Access Compliance Report Public Rights-of-Way (Curb Ramps)

Main Street: BRADBURY_RD Cross Street: ORLANDO_RD Location: NW

ADA ID: RPRK211208134918 Ramp Type: Type 1 - Perpendicular Diagonal Initial Pass/Fail: Pass Overall Compliance: No Severity Score: 15

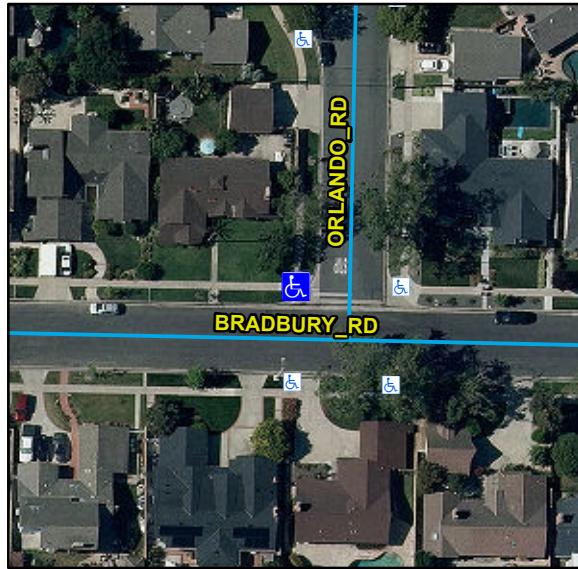
Compliance	Description	Data	Compliance	Description	Data
N/A	Ramp Length (in)	60	N/A	Flare Type LT	
Yes	Ramp Width (in)	48			Sloped
Yes	Ramp Run Slope (%)	6.3	N/A	Flare Slope LT (%)	2
Yes	Ramp Cross Slope (%)	1.4	N/A	Flare Traversable LT	No
N/A	Landing Present	Yes	N/A	Flare Type RT	
N/A	Landing Length (in)	48			Sloped
Yes	Landing Width (in)	48	N/A	Flare Slope RT (%)	9.9
Yes	Landing Run Slope (%)	1.3	N/A	Flare Traversable RT	No
Yes	Landing Cross Slope (%)	0.3	No	DWS Provided	No
N/A	Landing Movement Obstructed?	No	N/A	DWS Contrast	N/A
	Landing Movement Type	N/A	N/A	DWS Length (in)	N/A
N/A	Landing Shared	No	N/A	DWS Full Width	N/A
N/A	Clear Space	Yes	N/A	DWS Offset Left (in)	N/A
N/A	Clear Space To Crosswalk (in)	48	N/A	DWS Offset Right (in)	N/A
N/A	Marked Crosswalk 1	No	N/A	Marked Crosswalk 2	No
	Crossing 1 Direction	S		Crossing 2 Direction	E
	Marked Crosswalk 1 Width (in)	N/A		Marked Crosswalk 2 Width (in)	N/A

N/A	Ramp Inside Crosswalk 1	N/A	Yes	Ramp Inside Crosswalk 2	N/A
	Crossing 1 Slope (%)	8.2		Crossing 2 Slope (%)	2.1
	Crossing 1 Cross Slope (%)	2.2		Crossing 2 Cross Slope (%)	3.1
Yes	Gutter Ponding	No	Yes	Curb Slope	1.4
Yes	Gutter Lip Height (in)	0		Road Run Slope (%)	4
No	Gutter Run Slope (%)	5.1		Road Cross Slope (%)	0.4
No	Gutter Cross Slope (%)	3.5			
Yes	Overall Surface Condition: Acceptable		No	Perp Joint Present	No
	Cross Gutter Present?	Yes		Spandrel Present?	Yes
	Replace Cross Gutter?	No		Replace Spandrel?	No

Remove & Replace Curb Ramp With Two New Directional Ramps or Equivalent. Remove & Replace Gutter.
